PROJECT COMMENTS

PROJECT NUMBER: SP2025-041
PROJECT NAME: Site Plan for 1301 S. Goliad Street
SITE ADDRESS/LOCATIONS: 1301 S. Goliad Street

10/24/2025: SP2025-041; Site Plan for a Medical Office Building at 1301 S. Goliad Street
Please address the following comments (M= Mandatory Comments; I = Informational Comments)

MINDFUL WELLNESS
 1301 S. GOLIAD ST.
 SITE PLAN

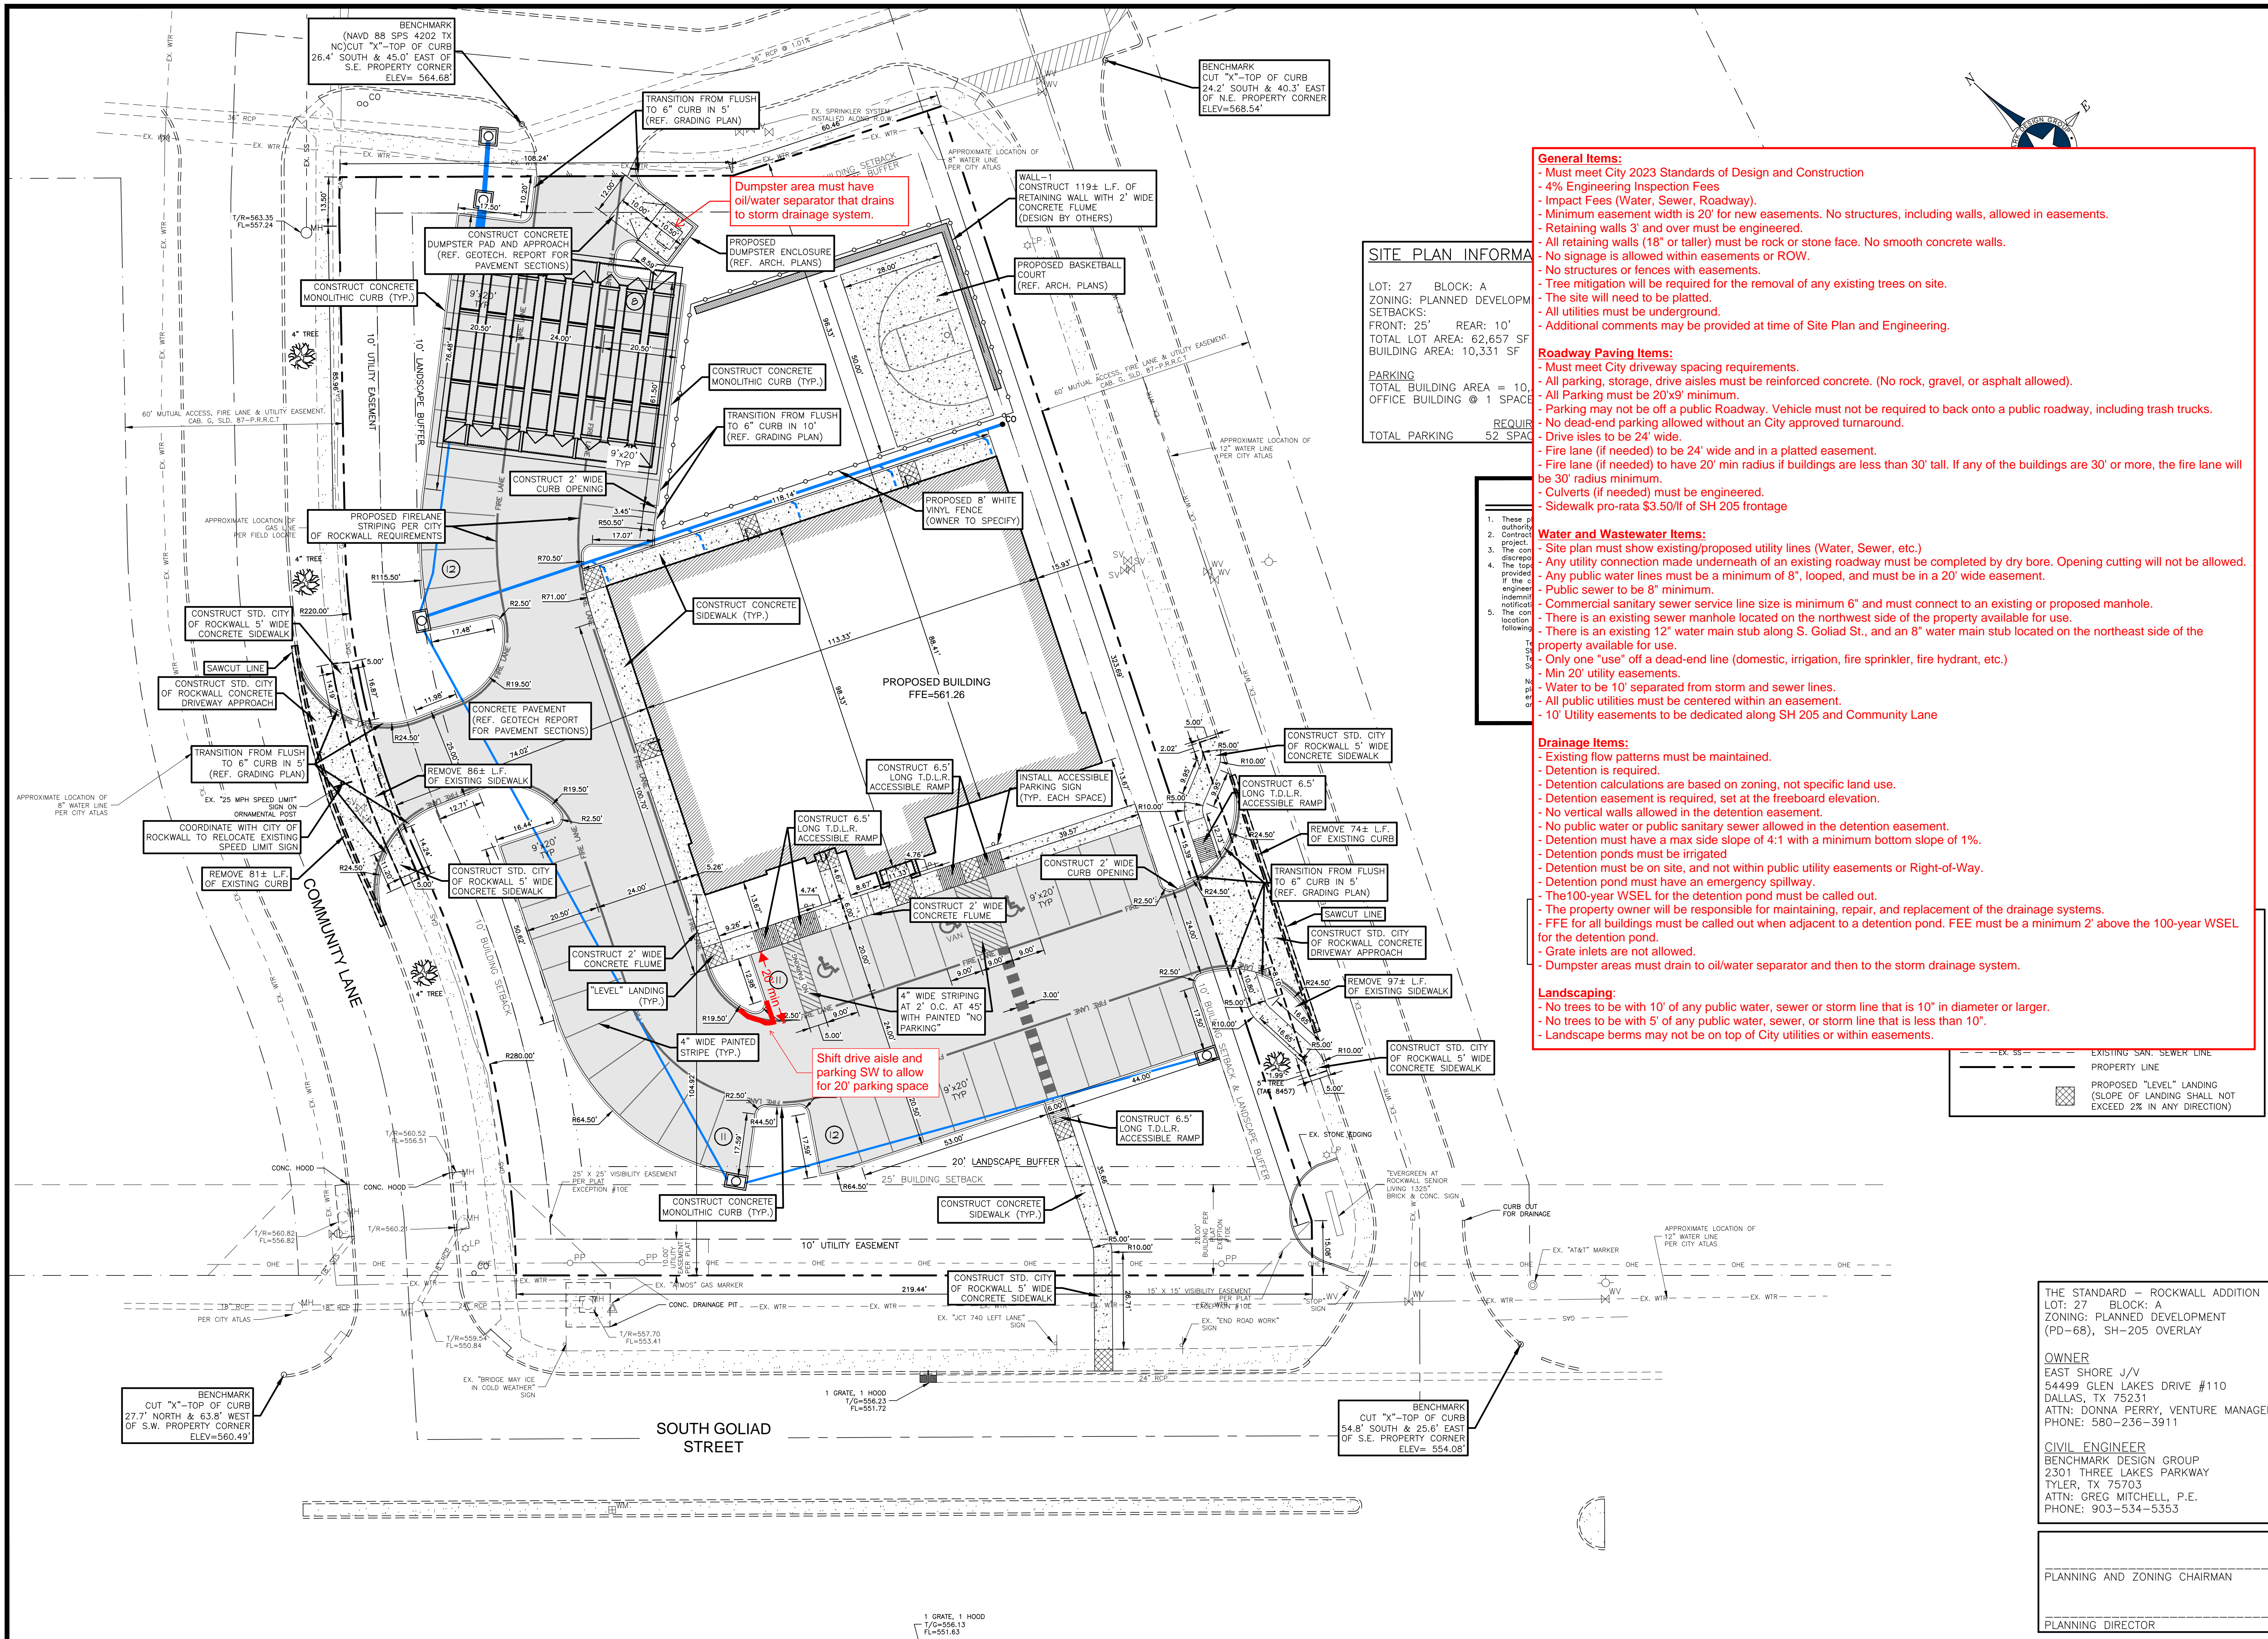
M.7 Site Plan.

- (1) Please provide a vicinity map that locates the site relative to the nearest major roadways in a one-half mile radius. (Subsection 03.04. B, of Article 11, UDC)

- (2) Please indicate the fire lane as Fire Lane, Public Access, and Utility Easement. (Subsection 03.04. B, of Article 11, UDC)
- (3) Indicate the type and depth of the paving material and provide a detail or cut-sheet. (Subsection 03.02, of Article 06, UDC)

- (4) Signage is done through separate permits with the Building Inspections Department. (Subsection 06.02. F, of Article 05, UDC)
- (5) Please indicate any existing or proposed fencing. Please delineate the location and provide the material and height. (Subsection 08.02. F, of Article 08, UDC)

- (6) All pad mounted equipment must be shown on the site plan. This equipment must be screened with five (5) gallon evergreen shrubs, which should be shown on the landscape plan. (Subsection 01.05.C, of Article 05, UDC)

- (7) Please provide a note that there shall no above ground storage tanks or outside storage, which includes vehicles. (Subsection 01.05. B, of Article 05, UDC)

- (8) Trash/Recycling enclosures shall be four (4) sided. These receptacles shall be screened by a minimum eight (8) foot, solid masonry dumpster enclosure that utilizes the same masonry materials as the primary building and incorporates an opaque, self-latching gate. Dumpster storage should be located to the rear of the buildings with proper access. Trash dumpster shall not be located in any required parking space and shall allow proper access by service trucks. The minimum enclosure area shall be 12'x10'. A minimum of 6" bollards will be required at potential impact zones and the pad site shall be paved to city standards. In addition, the current dumpster location faces towards residentially zoned property. Please turn the dumpster enclosure away from the residential subdivision.

- 10/23/2025: 1. Dumpster area must have oil/water separator that drains to storm drainage system.
 2. Shift drive aisle and parking SW to allow for 20' parking space.
 3. 20' min.

Exterior Material Specifications

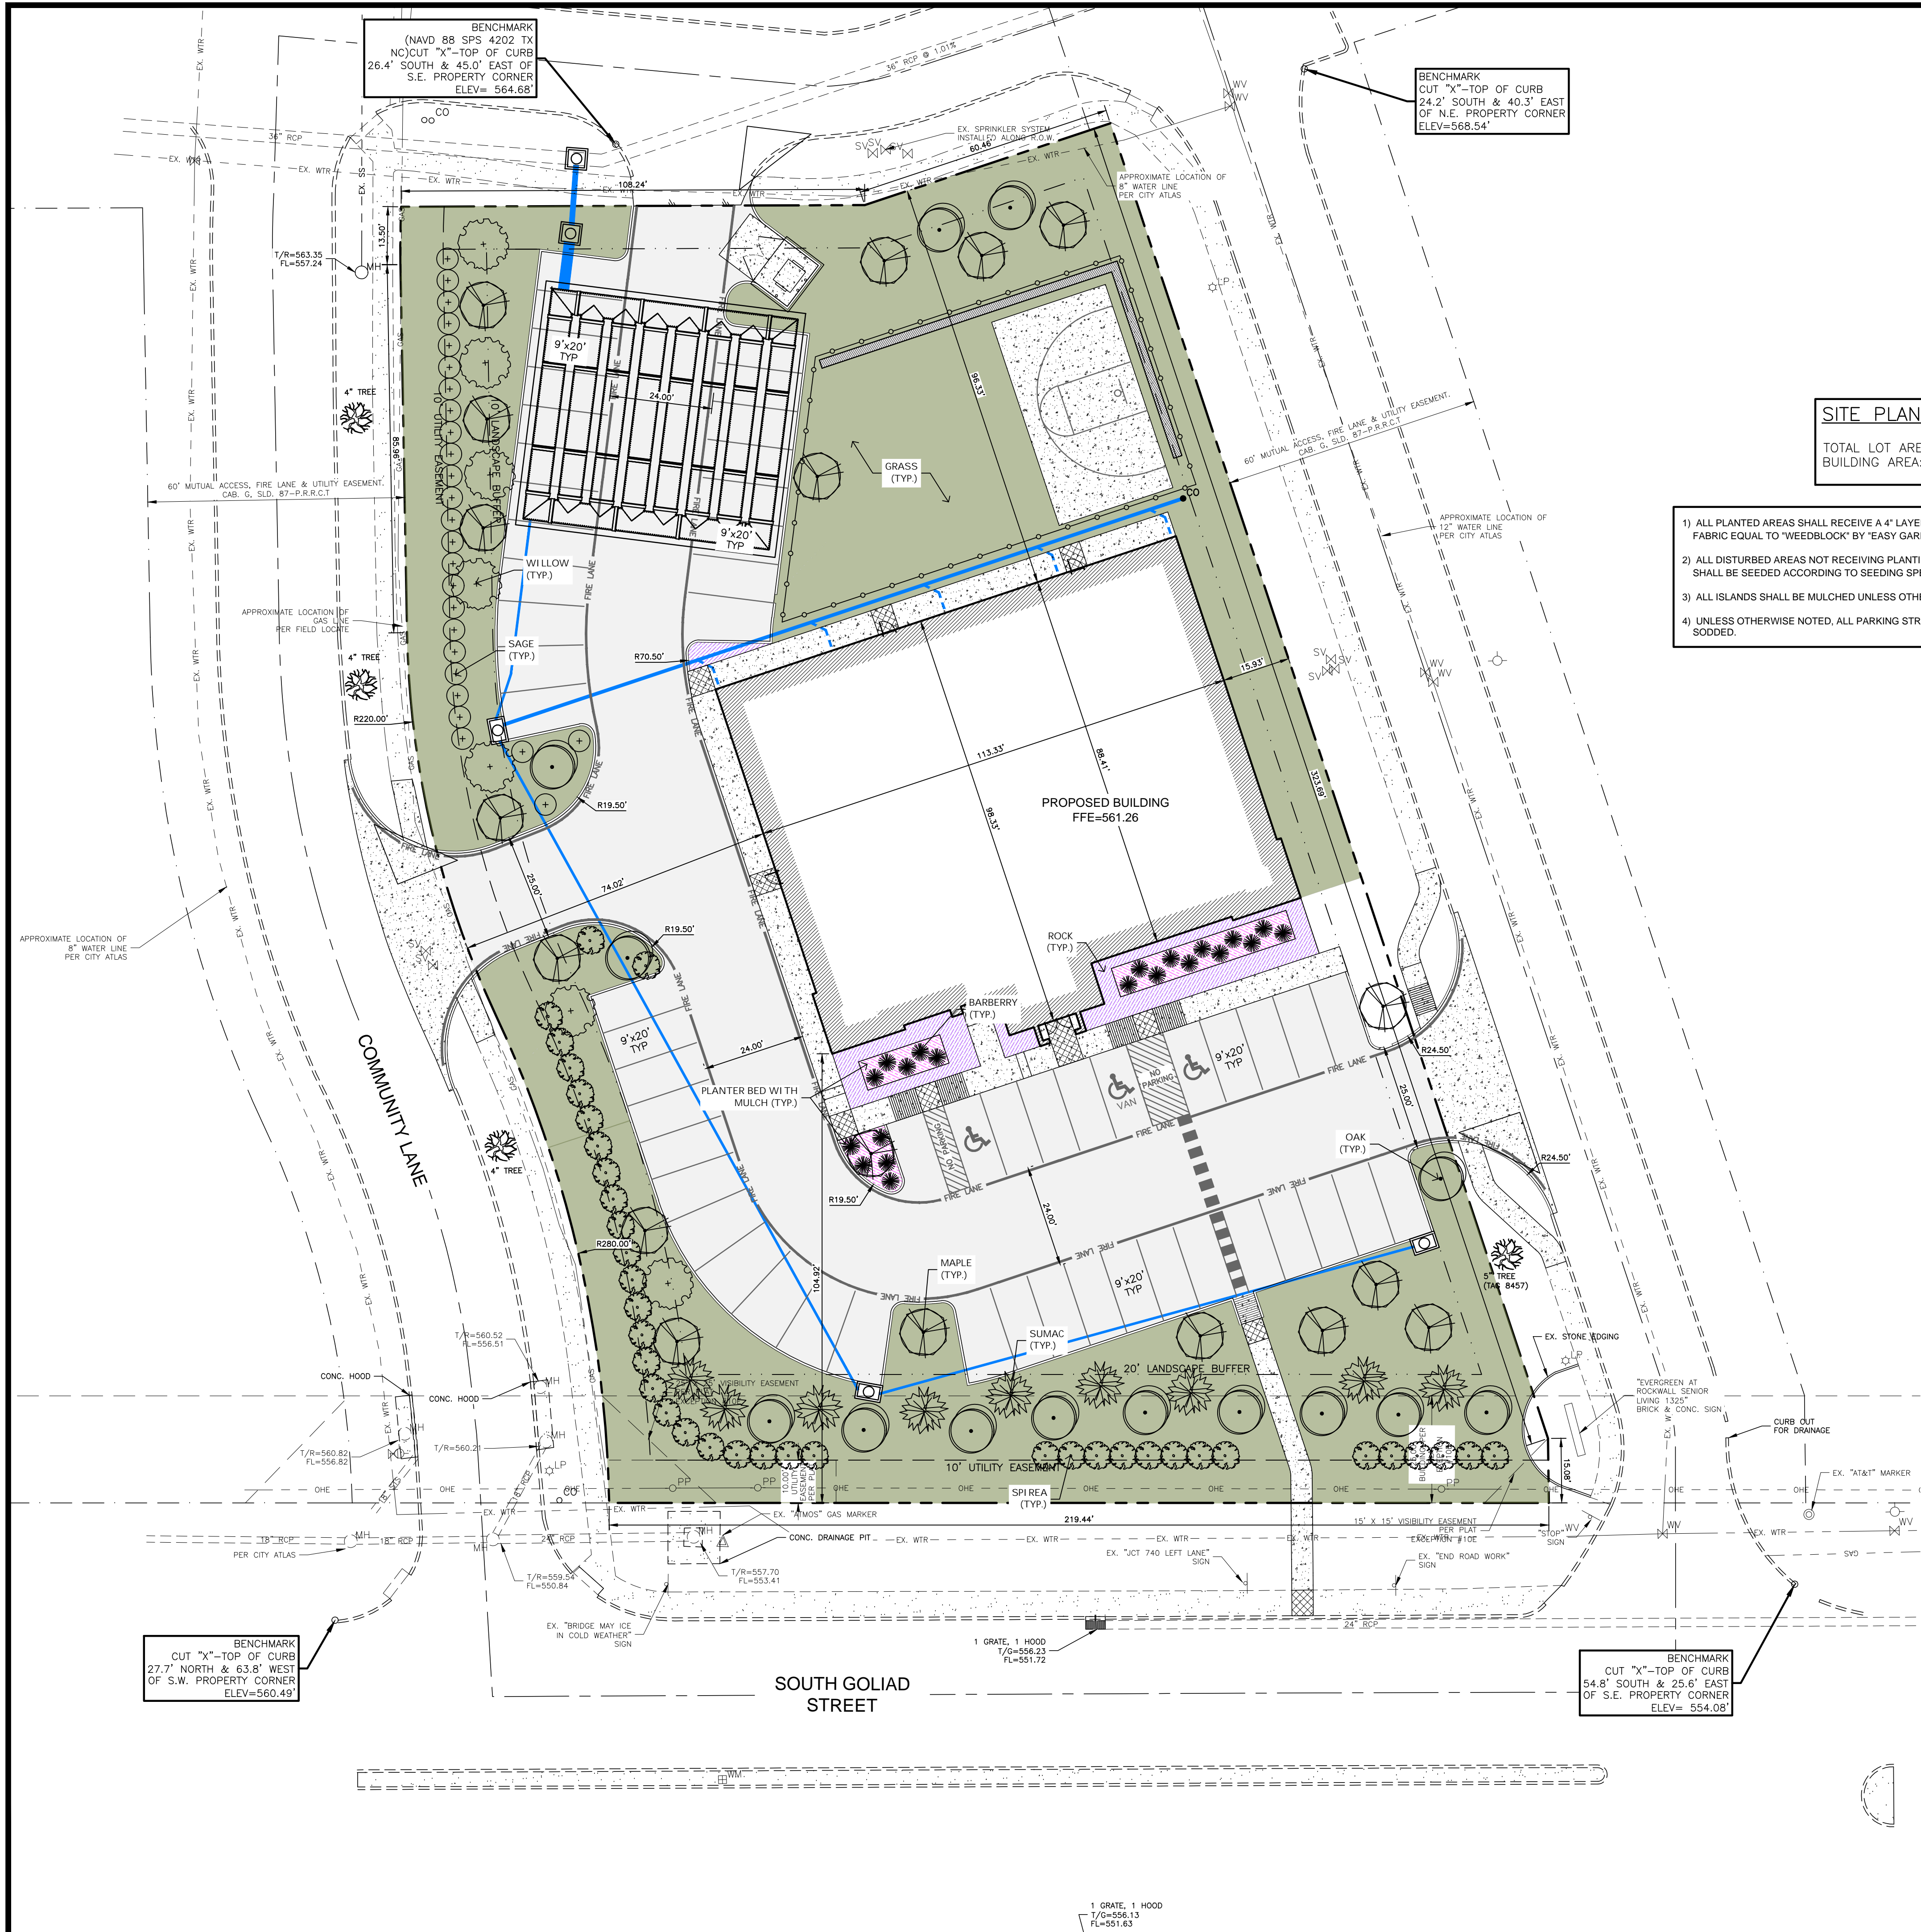
- (1) The subject property is located within an Overlay District. This requires that the stone be natural or quarried. In this case, the proposed stone appears to be cast. Please propose a different stone or this will be a Variance request. (Subsection 06.02, of Article 05, UDC)
- (2) EIFS is not an approved masonry material, rather three (3) part stucco will need to be utilized. (Subsection 06.02, of Article 05, UDC)

- (3) The subject property is located within an Overlay District. This requires that each façade cannot utilize more than 50% cementitious material. In this case, the north and east façade exceeds this requirement. Please correct this or this will be a Variance request. (Subsection 06.02, of Article 05, UDC)

- (4) Please include a note on the building elevations that indicate that the back side of the parapets will incorporate the same material as the exterior facing façade. (Subsection 06.02, of Article 05, UDC)

- (5) All roof mounted equipment must be crosshatched on the building elevations. This equipment must be fully screened. (Subsection 01.05.C, of Article 05, UDC)

- (6) Indicate any additional design elements for the base, walls, or parapets (such as cornice, arcades, and covered walkways/windows). Staff should note that the Architectural Review Board (ABR) will be looking for canopies over any exterior doors. (Subsection 01.05.C, of Article 05, UDC)

- (7) The subject property is located within an Overlay District. This requires four (4) sided architecture where all sides of the building must utilize the same materials, detailing, articulation and features. In this case, the detailing, features, and articulation are not the same on each side. Please provide four (4) sided architecture or this will be a Variance request. (Subsection 06.02, of Article 05, UDC)

- (8) In addition, the comment above, the four (4) sided architecture requires the primary articulation standards to be used on each side of the building. Please see the areas of non-conformance below. Please correct this or this will be a Variance request. (Subsection 06.02, of Article 05, UDC)

- a. Wall Height: (conforming)
 - b. Wall Length: maximum permitted = 51'6" (non-conforming on north, west, and east sides)
 - c. Secondary Entry Element Width: minimum permitted = 12'10" (non-conforming on south side, and north, east, and west have no secondary element)

- d. Wall Projection: minimum permitted = 4'3" (non-conforming on all sides)
 - e. Primary Entry Element Depth: minimum permitted = 8'6" (non-conforming on all sides)

- f. Projection Height: minimum permitted = 4'3" (non-conforming on all sides)
 - g. Primary Entry Element Width: minimum permitted = 25'8" (non-conforming on south side, and north, east, and west have no primary element)

10/23/2025: * Back sides of the parapet walls to be finished with the same material as the front

* Must be 3-part stucco, listed as stucco

* Materials indicate EIFS, which is not allowed, must be 3-part stucco

MINDFUL WELLNESS
 1301 S. GOLIAD ST.
 LANDSCAPE PLAN

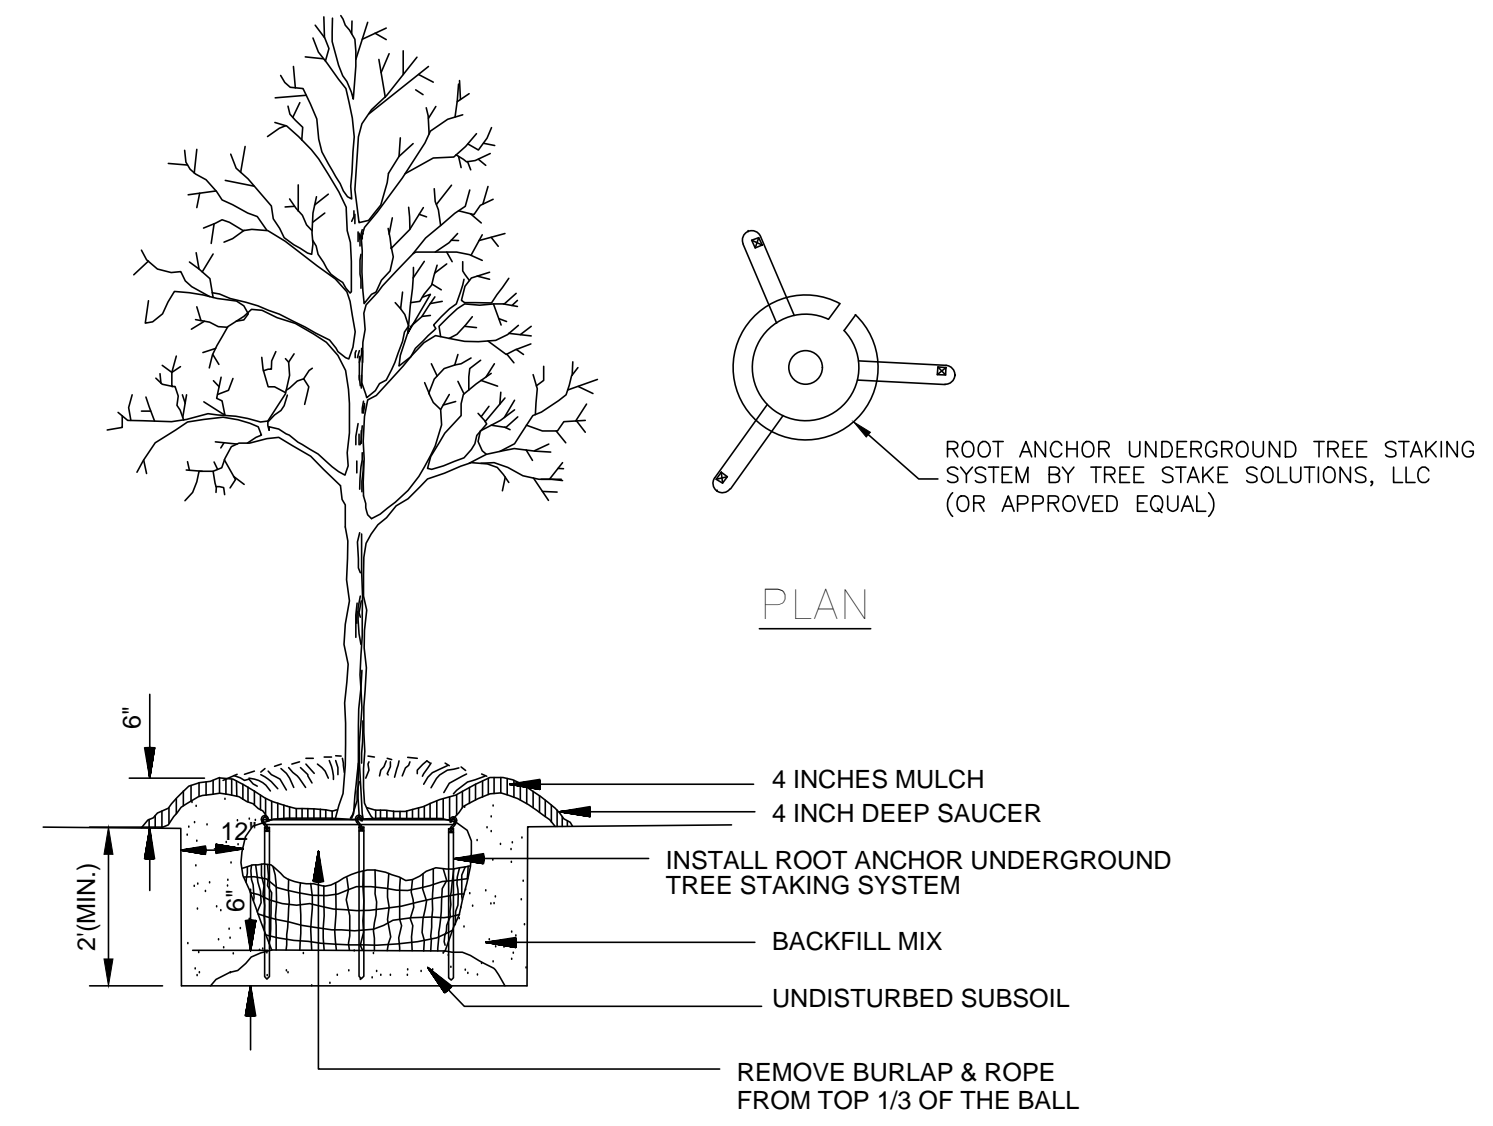
M.8 Landscape Plan.

- (1) Provide the same site data information required in Section 2.1 Site Plan: Miscellaneous and Density and Dimensional Requirements of this checklist. (See Sec. 2.1 of the checklist)

- (2) Please provide three (3) tiered landscape screening along the northeast property line. (Subsection 05.02.B, of Article 08, UDC)
- (3) Please provide one (1) canopy tree and one (1) accent tree per 50-linear feet along the east access easement. This can serve as a compensatory measure. (Subsection 05.05, of Article 08, UDC)

- (4) All pad mounted equipment must be shown; this includes franchise utilities. This equipment must be screened with five (5) gallon evergreen shrubs, which should be shown on the landscape plan. (Subsection 01.05.C, of Article 05, UDC)

- (5) All shrubs shall be five (5) gallon. (Subsection 05.05. B, of Article 08, UDC)
- (6) All parking spaces that face onto a roadway must have a row of 5-gallon evergreen shrubs planted in front of them for headlight screening. (Subsection 05.03, of Article 08, UDC)

- (7) All landscaping must be irrigated with an underground system. (Subsection 05.04, of Article 08, UDC)
- (8) Please delineate and label the required berms within the landscape buffers. (Subsection 06.02, of Article 05, UDC)
